TSG-RAN Meeting #6 **_TSGRP#6(99)676_**
Nice, France, 13 – 15 December 1999

Title: **Agreed CRs of category "D" (Editorial) to TS 25.211**

Source: **TSG-RAN WG1**

Spec	CR	Rev	Phase	Subject	Cat	Version-Current	Version-New	Doc
25.211	006	-	R99	Change to the description of TSTD for SCH	D	3.0.0	3.1.0	R1-99i47
25.211	008	1	R99	Modifications to STTD text (*1)	D	3.0.0	3.1.0	R1-99j26
25.211	010	-	R99	Update to AICH description	D	3.0.0	3.1.0	R1-99i49

Figure 16: STTD encoding for the data bits ~~symbols~~ of the P-CCPCH.

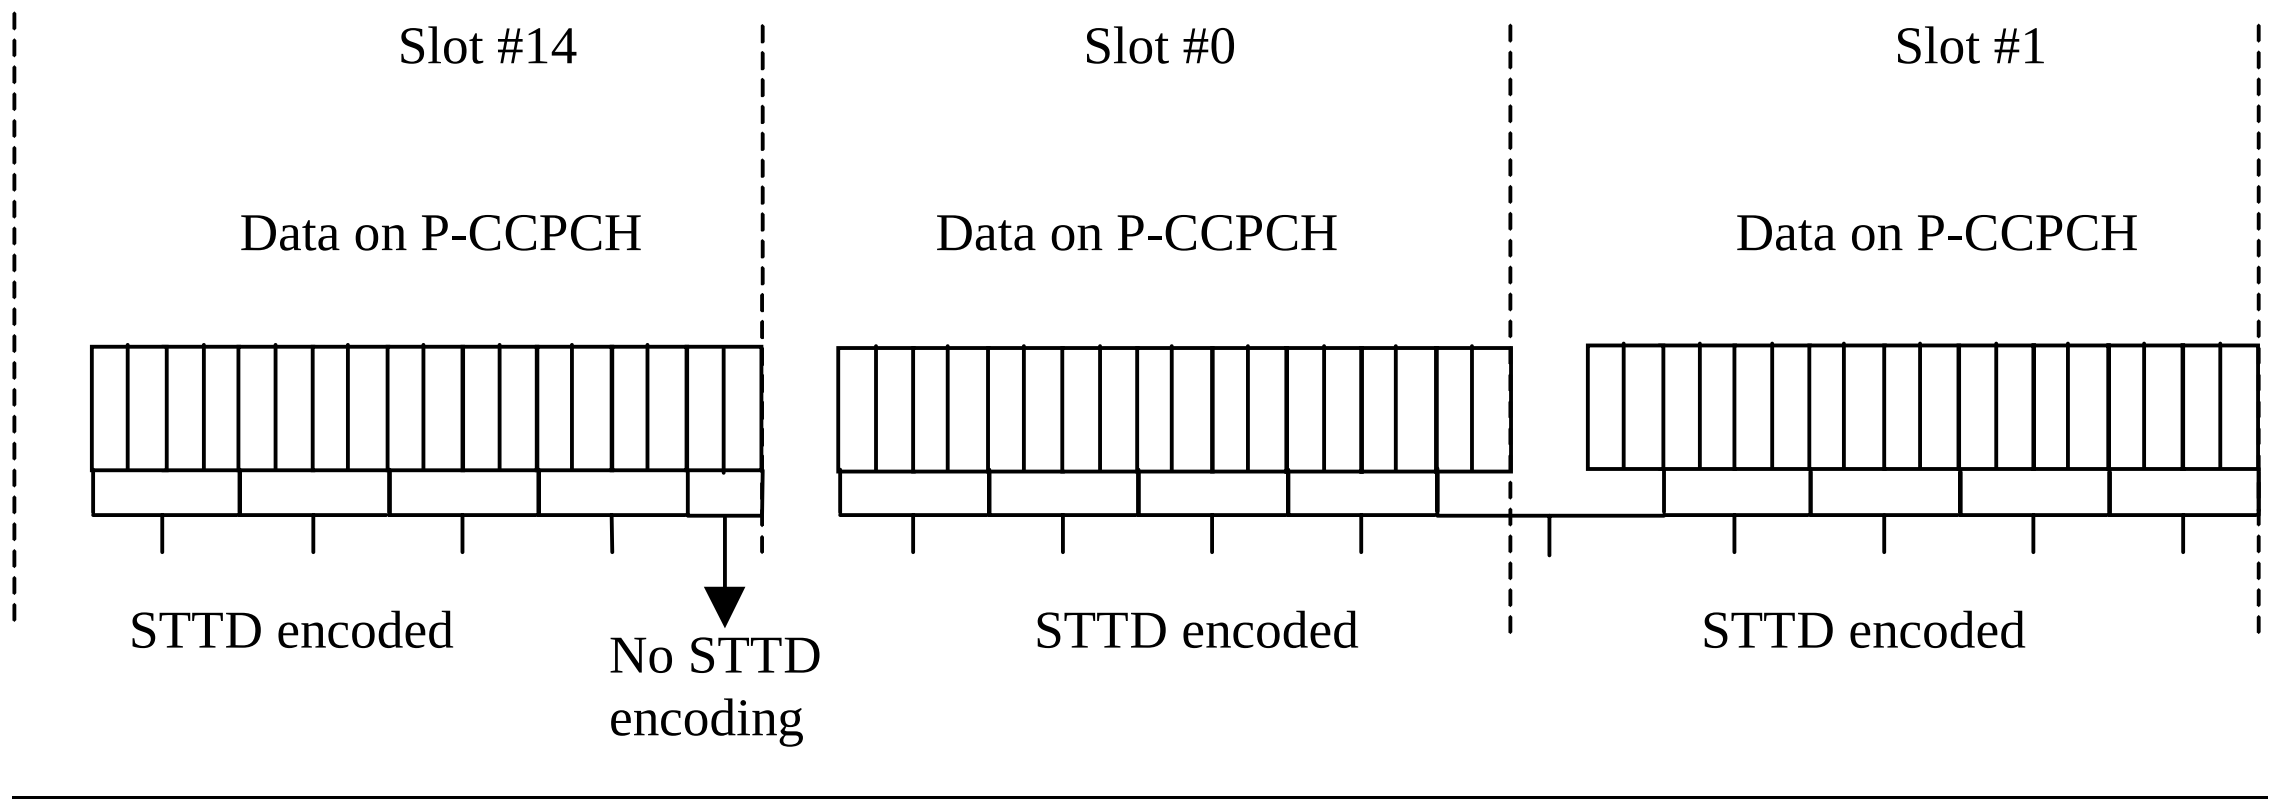
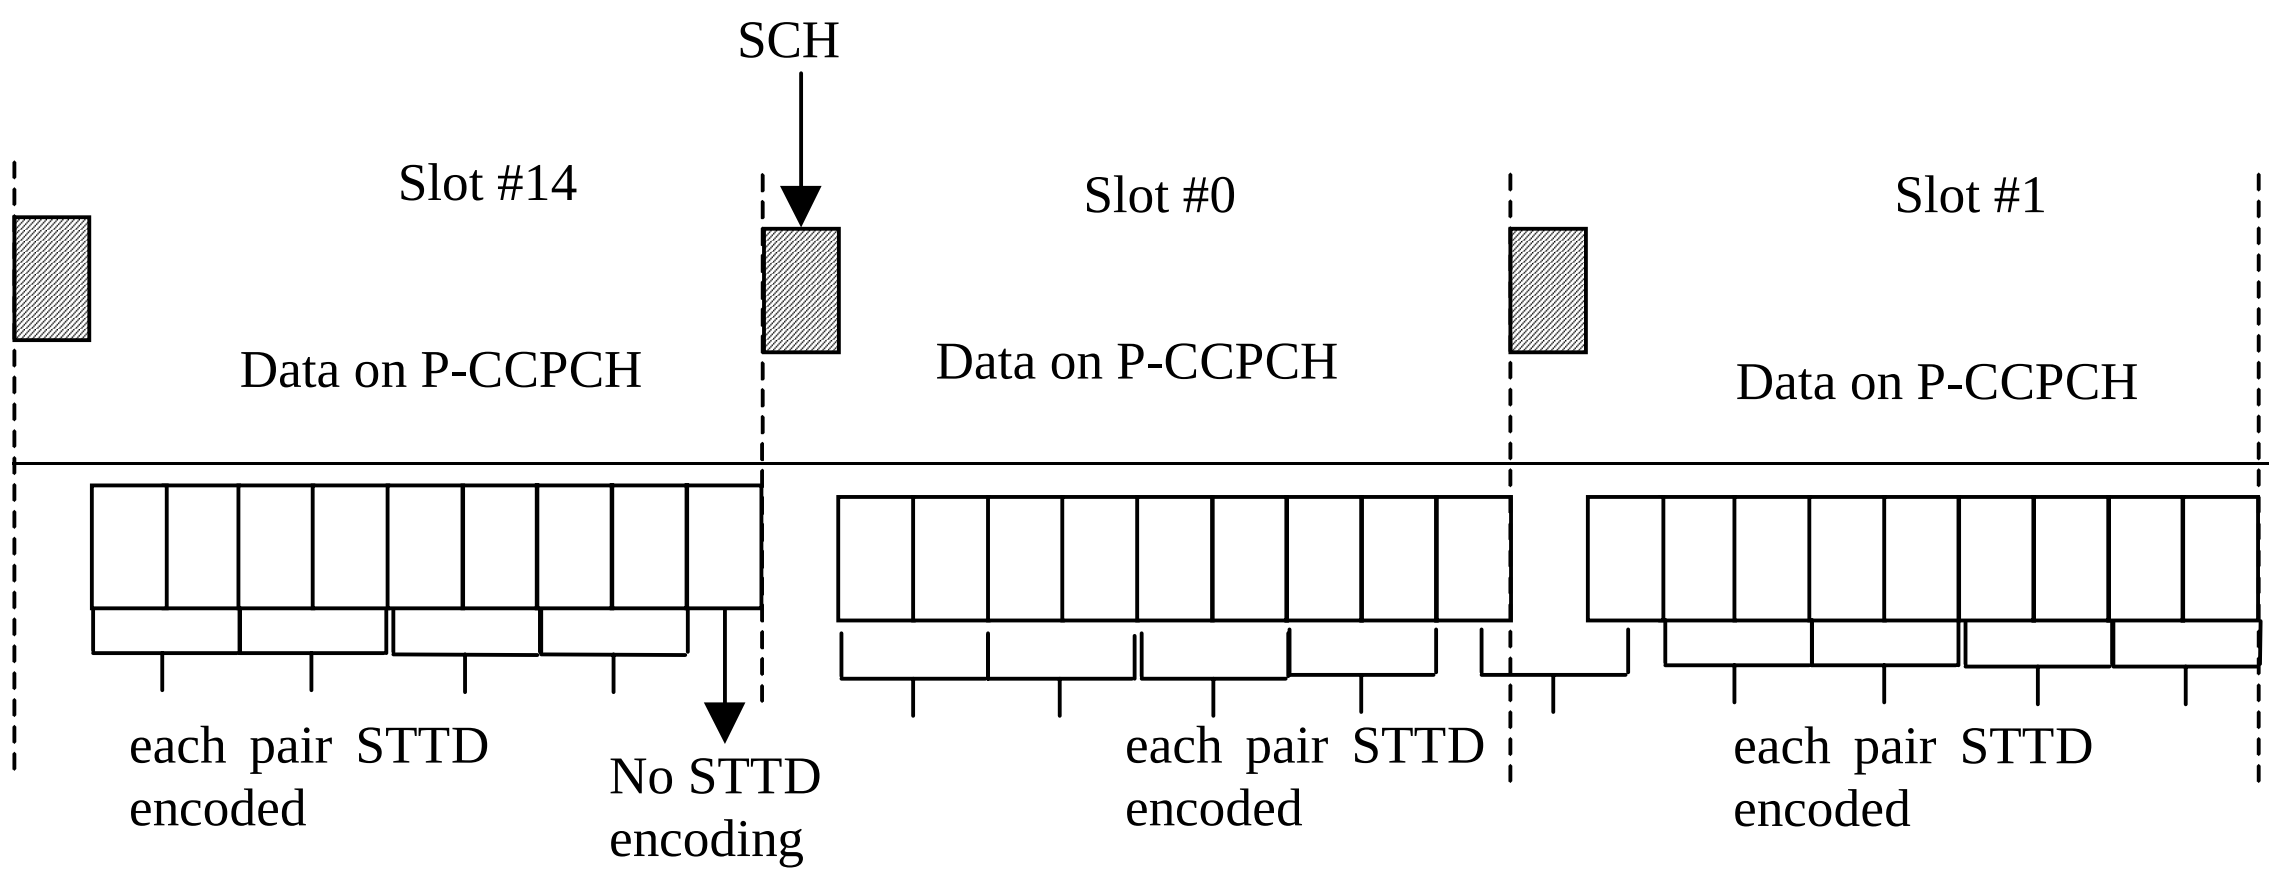
In case the diversity antenna is present in UTRAN and the P-CCPCH is to be transmitted using open loop transmit diversity, the data bits~~symbols~~ of the P-CCPCH are STTD encoded as given in section 5.3.1.1.1, ~~Figure 7 and Figure 8~~. The last two data bits in even numbered slots are STTD encoded together with the first two data bits in the following slot, except for slot #14 where the two last data bits are not STTD encoded and instead transmitted with equal power from both the antennas, see Figure 16. ~~The last odd data symbol in every frame (10 ms) is not STTD encoded and the same symbol is transmitted with equal power from the two antennas.~~ Higher layers signal whether STTD encoding is used for the P-CCPCH or not. In addition, higher layer signalling indicates the presence/absence of STTD encoding on P-CCPCH, by modulating the SCH. During power on and hand over between cells the UE determines the presence of STTD encoding on the P-CCPCH, by either receiving the higher layer message, by demodulating the SCH channel or by a combination of the above two schemes.

~~The STTD encoding for the data symbols of the slots 0 and 1 of a P-CCPCH frame is given in the Figure 16. The same procedure is used for the data symbols of slots 2 and 3, 4 and 5 and henceforth, respectively.~~

Figure 21: Structure of Acquisition Indicator Channel (AICH).

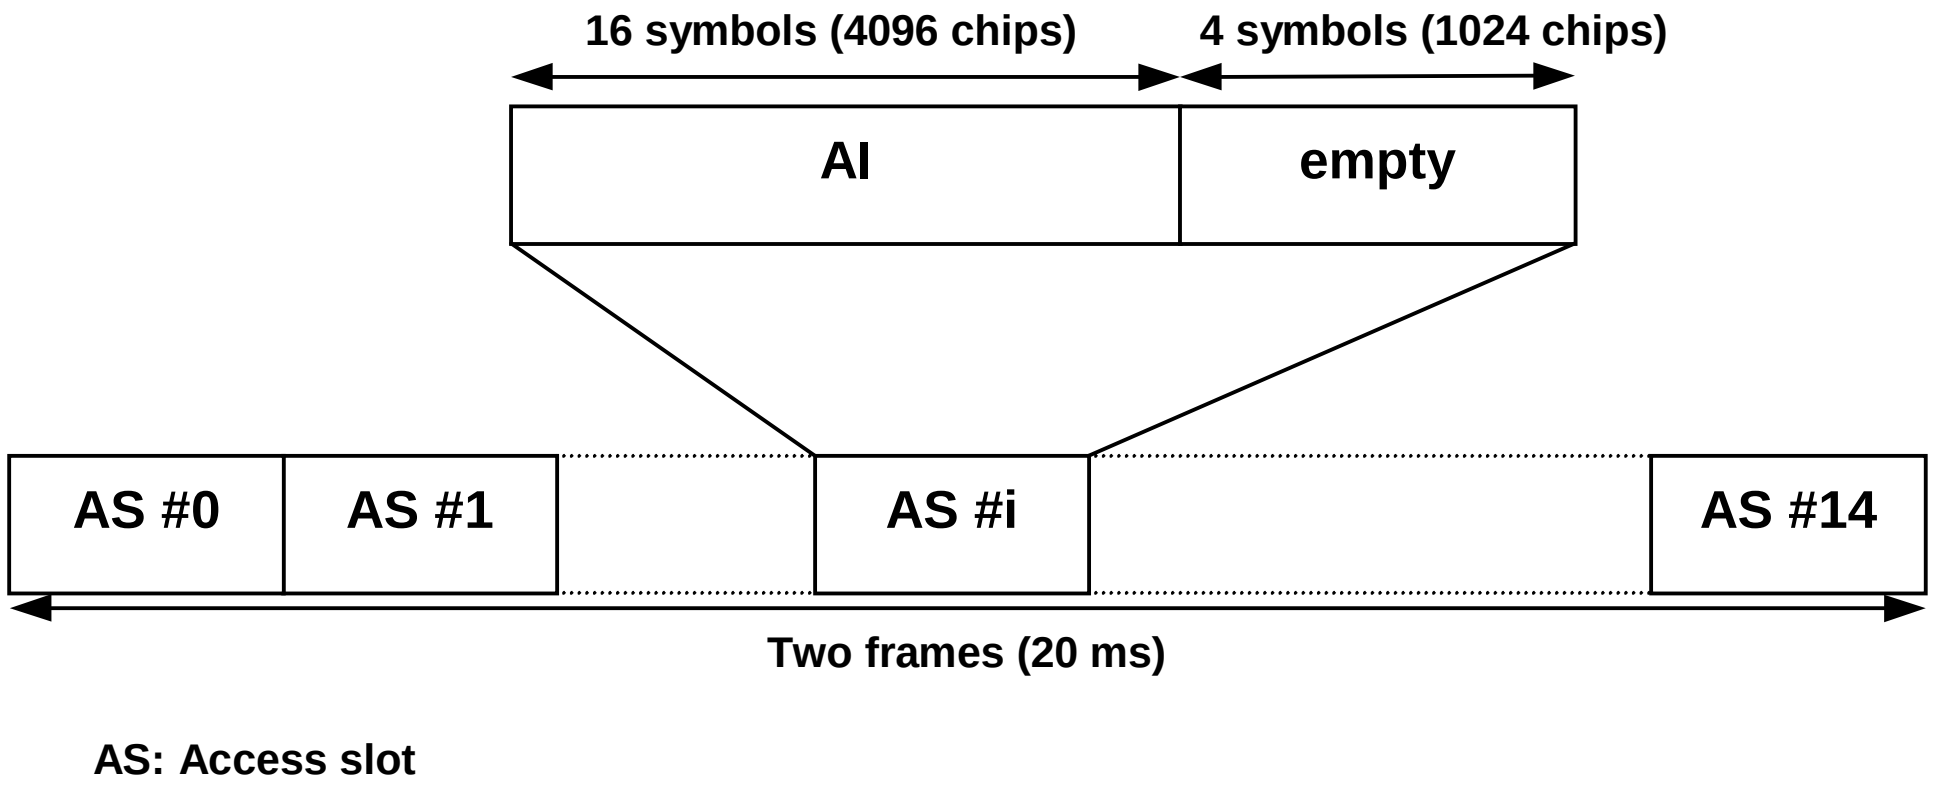
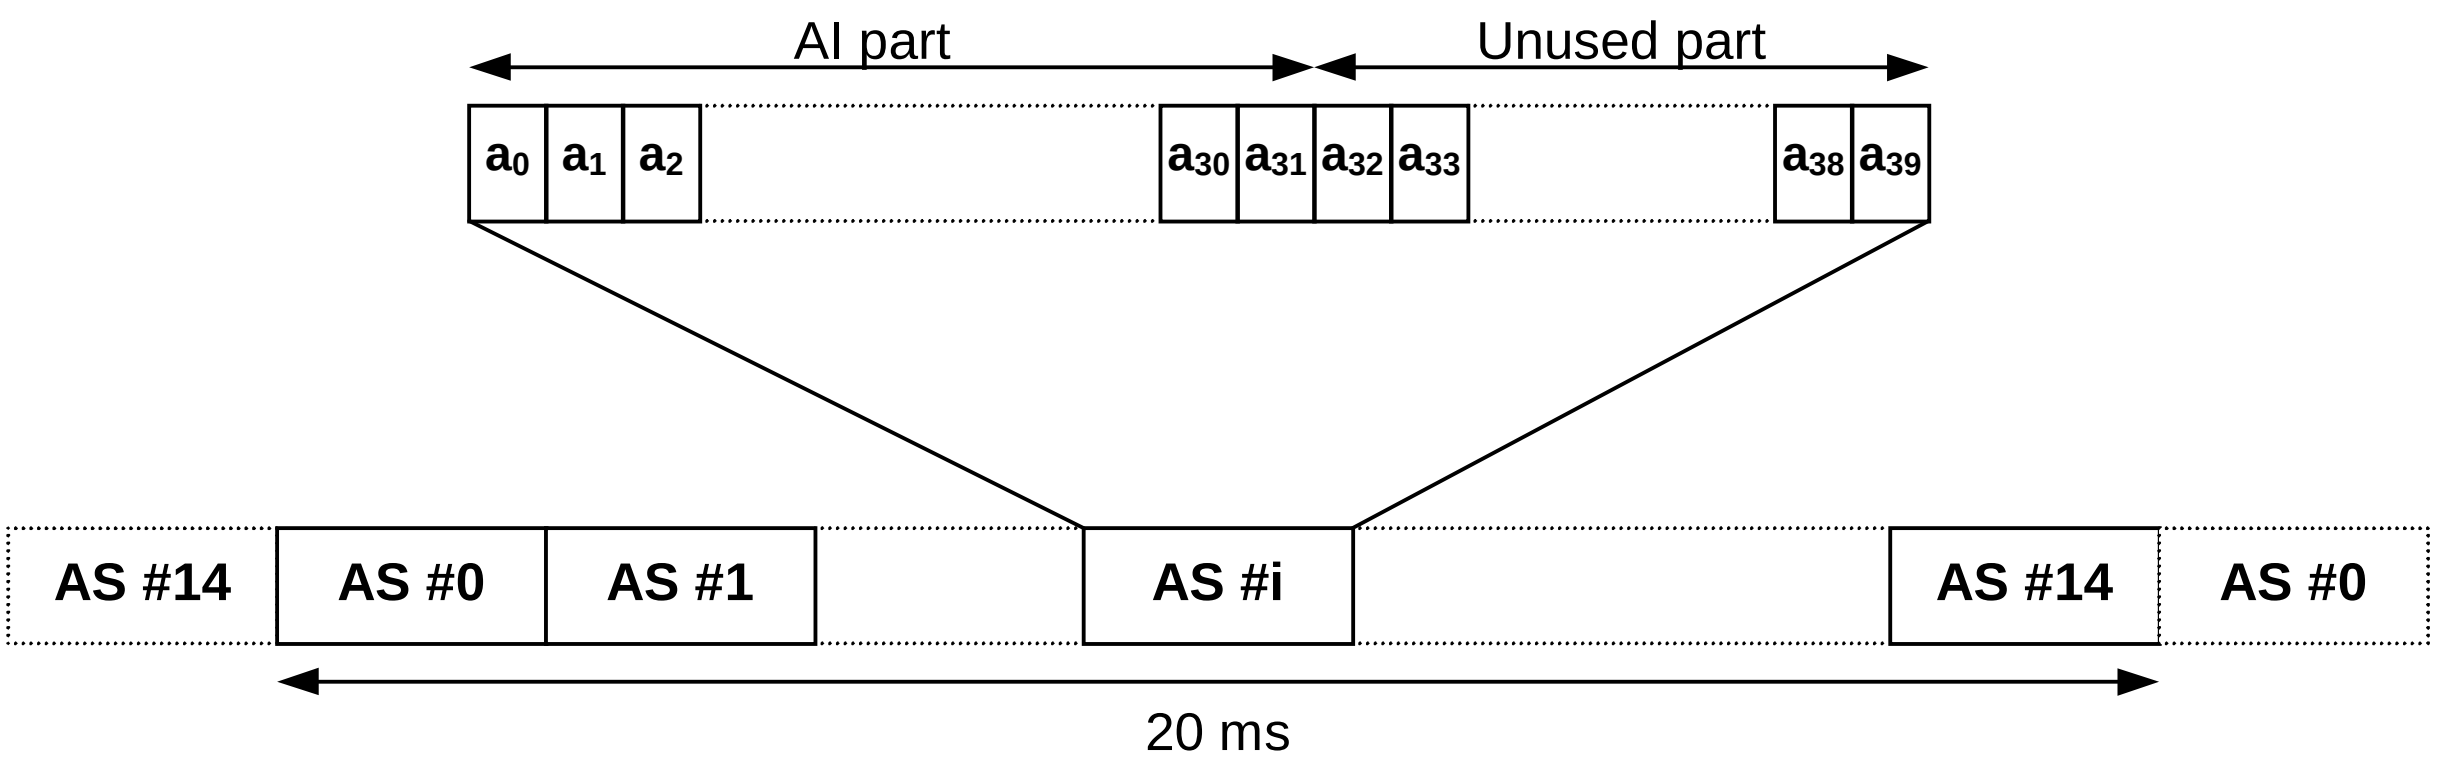
- The "two frames" in Figure 21 is removed. It is not clear what these "frames" refers to. It does not seem to be necessary to define an *AICH frame*.
- The description of the generation of the AICH is moved from 25.213 to 25.211. The reason is that this description deals with the generation of non-spread AICH symbols and does not seem to be related to spreading.

Figure 21 illustrates the structure of the AICH. The AICH consists of a repeated sequence of 15 concecutive *access slots* (AS), each of length 40 bit intervals. Each access slot consists of two parts, an *Acquisition-Indicator* (AI) part consisting of 32 real-valued symbols a_0, …, a_{31} and an unused part consisting of 8 real-valued symbols a_{32}, …, a_{39}.
